CITY OF LAKE GENEVA
PLAN COMMISSION MEETING
MONDAY, OCTOBER 19, 2015- 6:30 PM
COUNCIL CHAMBERS, CITY HALL

STAFF REPORT
To Lake Geneva Plan Commission

Subject: Review of Certified Survey Map and Site Plans by Key Development Partners, LLC (for Home Depot USA Inc.) in the City of Lake Geneva

CERTIFIED SURVEY MAP NO. _____

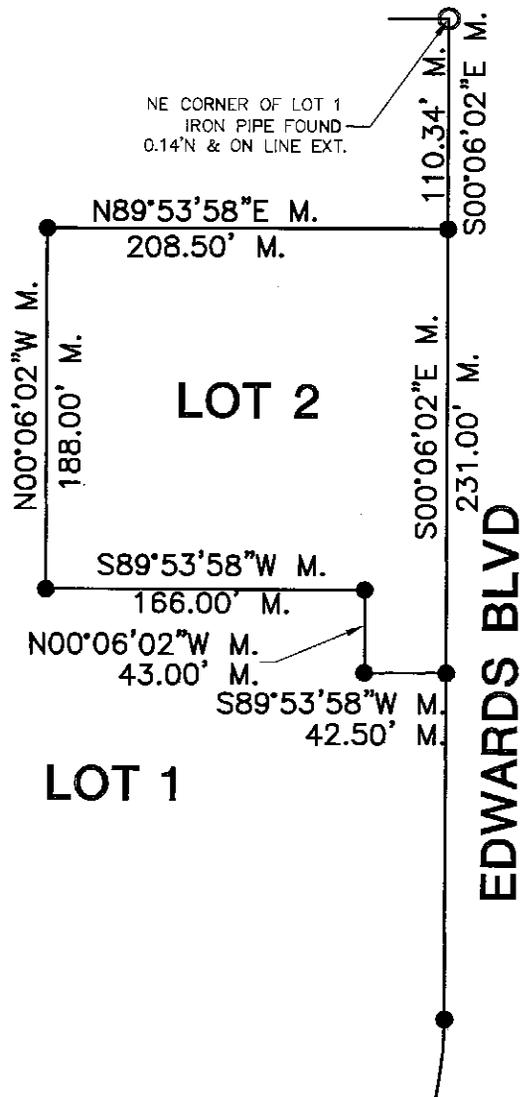
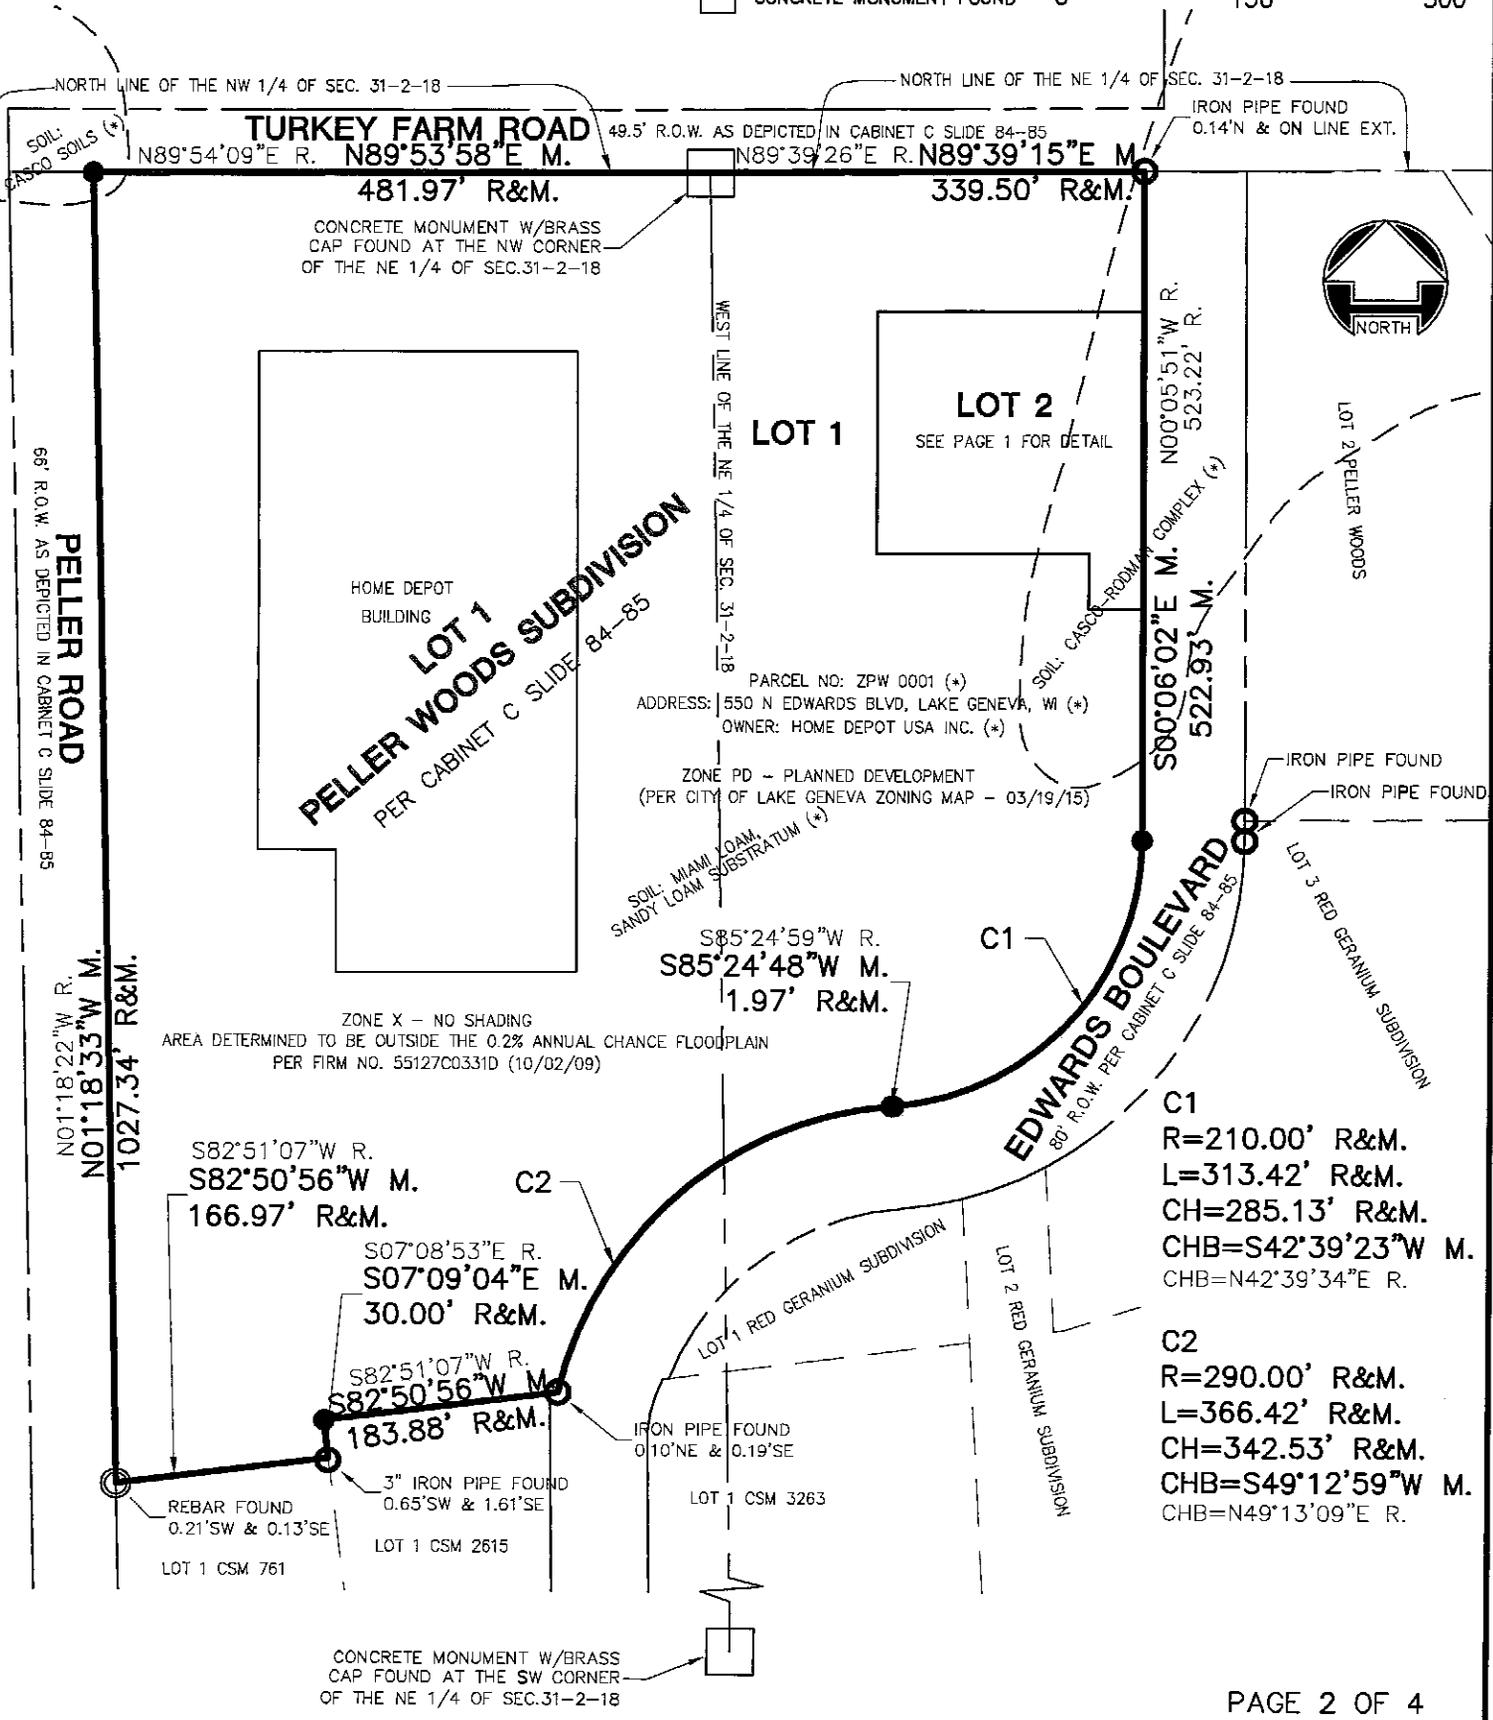
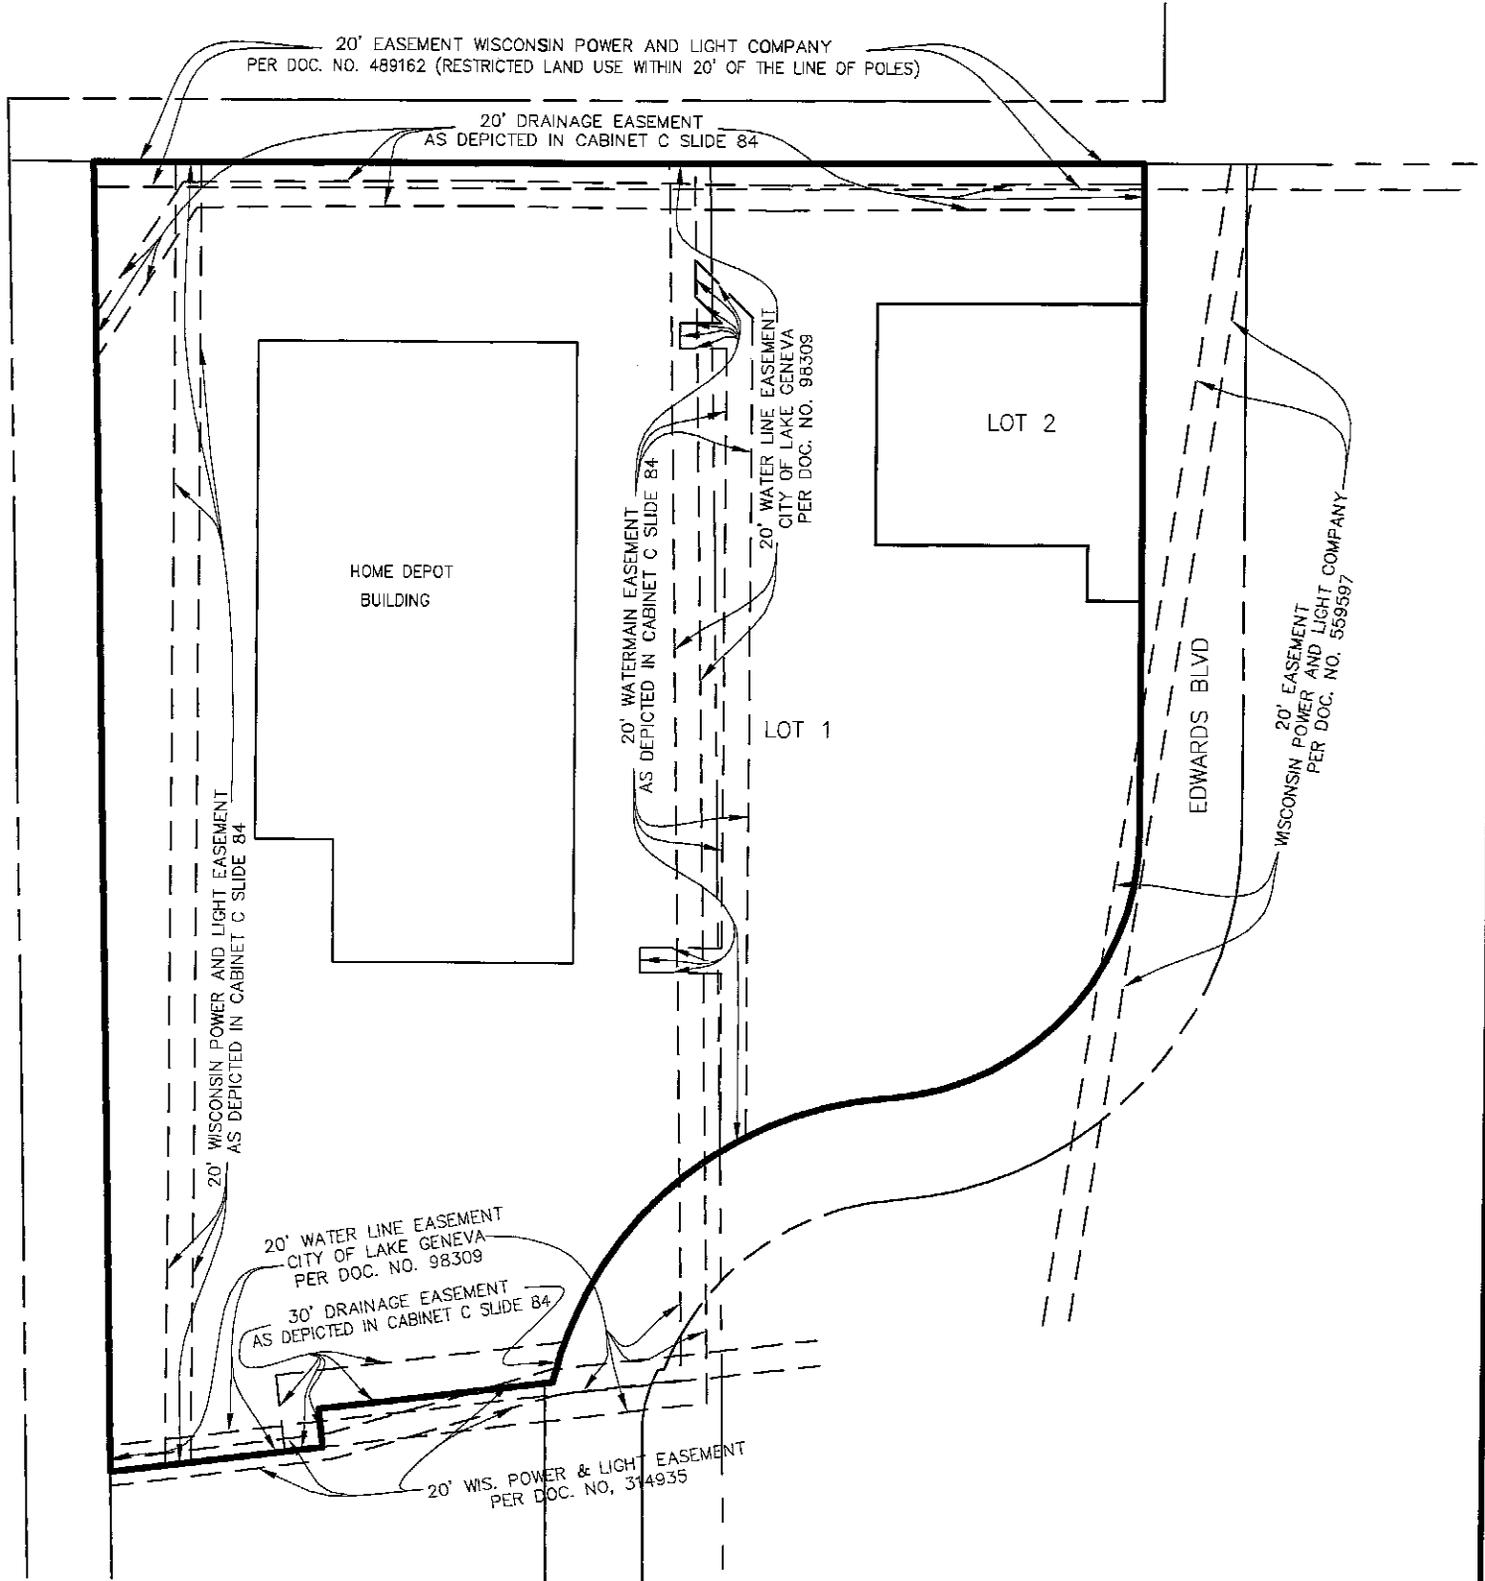
- As per s.236.20 (2(b)) - Please indicate the outside diameter of all monuments.
- As per s.236.20 (3(d)) - Please underscore adjoining street and subdivisions with dashes or dots.
- As per s.236.20 (2(k)) - Please indicate the central angle subtended and tangent bearings for each of the curves.
- As per s.236.34 (1(d(3))) - Please revise the Surveyors Certificate to include "and dedicated" if this is warranted in the addition of right of way on Turkey Farm Road.
- As per s.236.34 (ar) - Please remove the Department of Administration and Walworth County Planning from the Owner's Certificate.
- As per sec. 66-36(1) – Please remove the City Council Resolution Certificate show only the Plan Commission Approval Certificate with the City Clerk Resolution note.

SHEET NO. **C200**

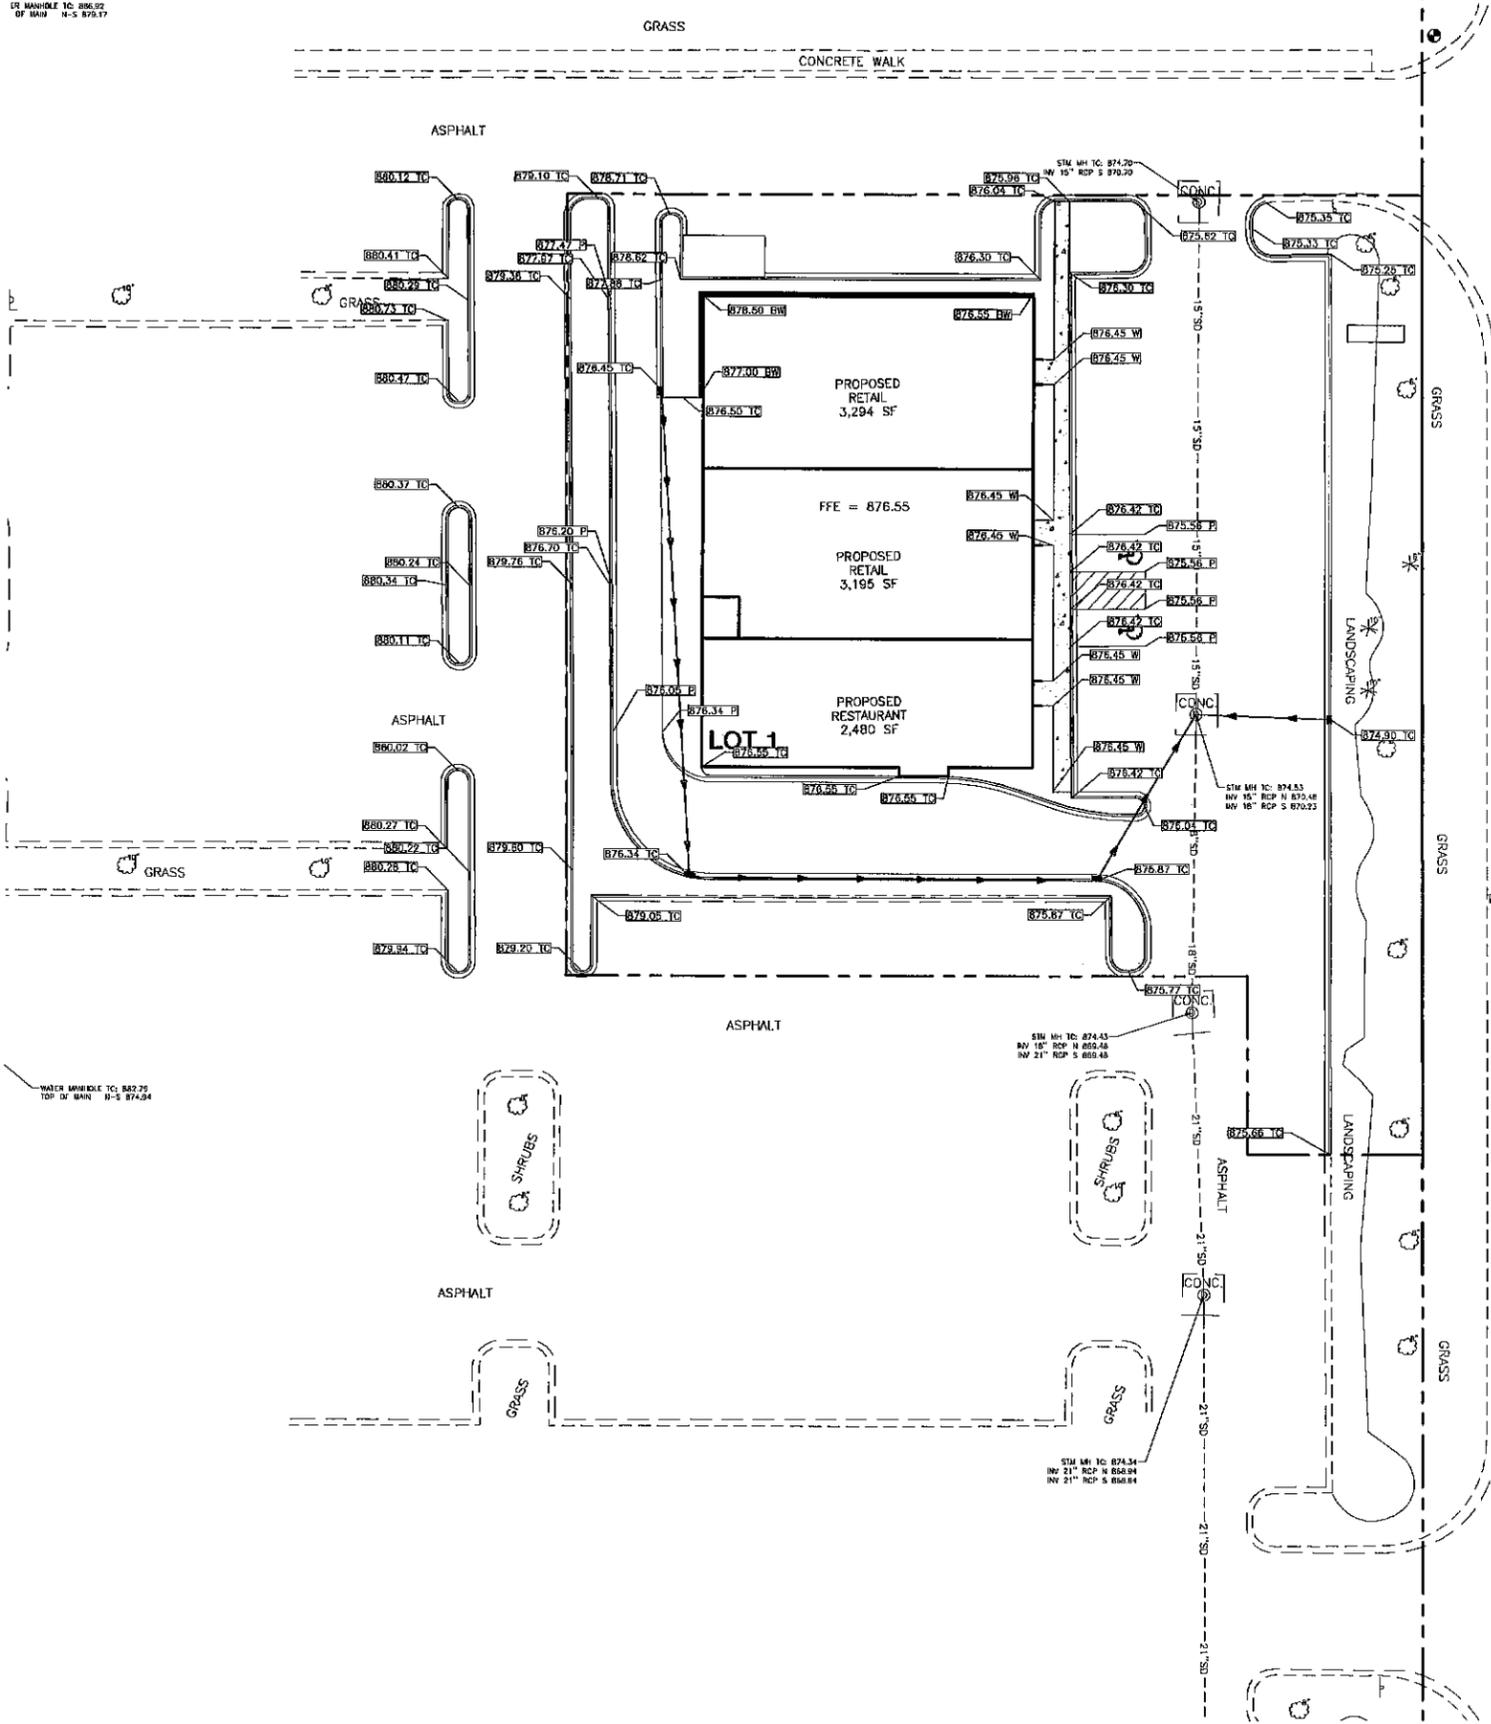
Sheet C200 Review Comments:

- Protective bollards have not been shown on the site plan. They may need to be considered at the drive through window area and southwest corner of the building.

- Update the site legend to reflect current project applicability requirements and detail call outs.
- A 6" Water main is shown entering the service room somewhere from the west. Please provide detail in the PIP submittal. Trench work and restoration associated with the installation of the new water main service shall be shown on the plans.

- The Final grading plan shall detail the accessible ramps and associated grades. WisDOT standards ramps types shall be followed.

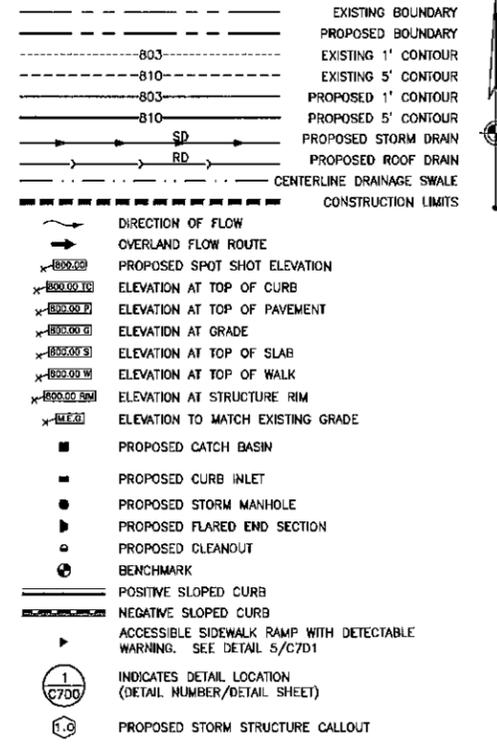
Sheet C300 Review Comments:

- Please confirm that the existing light pole in the northeast island is being removed. Trench work and restoration associated with the installation of the new lighting shall be shown on the plans.
